**SYDNEY WATER  
BUILDING PLAN APPROVED  
SUBJECT TO REQUIREMENTS**

Building/Structure Description: NEW RESIDENCE

Building Plan No: A18825

**LETTER of APPROVAL  
For  
BUILDING OVER/ADJACENT TO A SYDNEY WATER ASSET**

**BARTLETT PLACE**  
**SITE ANALYSIS & SITE PLAN 1:200**

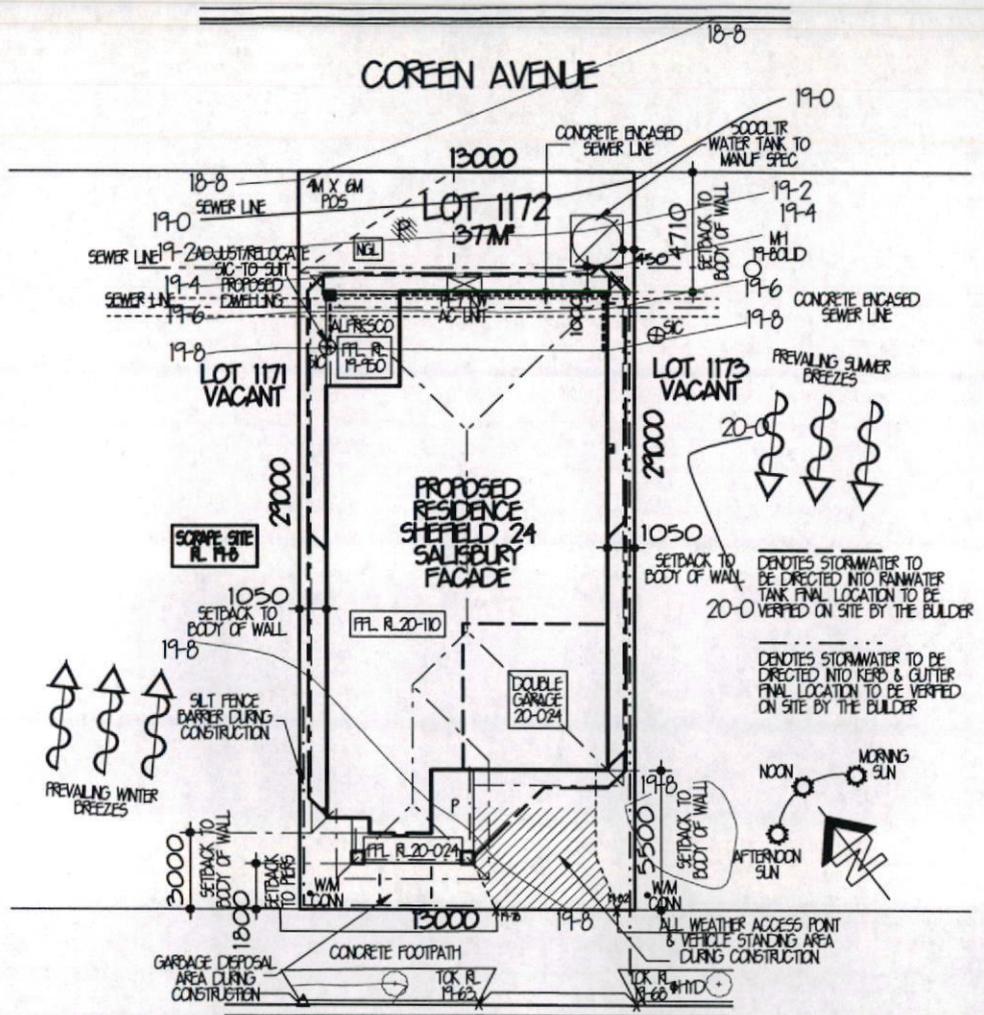
1. The foundations/piers are to be founded below 1:1 zone of influence, CLAY strata.
2. No part of the building/structure or its foundations to be less than a minimum 0.6 metre, horizontal distance from the centreline of the asset.

4. No part of the building/structure or swimming pool coping to be less than 1m horizontal distance from outside edge of any Sydney Water structure.
5. No piercing of building/structure to be less than 2m horizontal distance from centreline of maintenance hole to edge of piers.

6. Foundations/piers are constructed in accordance with Engineers detail plans (stated above) as submitted to Sydney Water.
7. All foundations/piers are to be founded below the zone of influence or to solid rock.

- No piers within 900mm of the affected pipe.
- All piers are to be founded below the zone of influence.
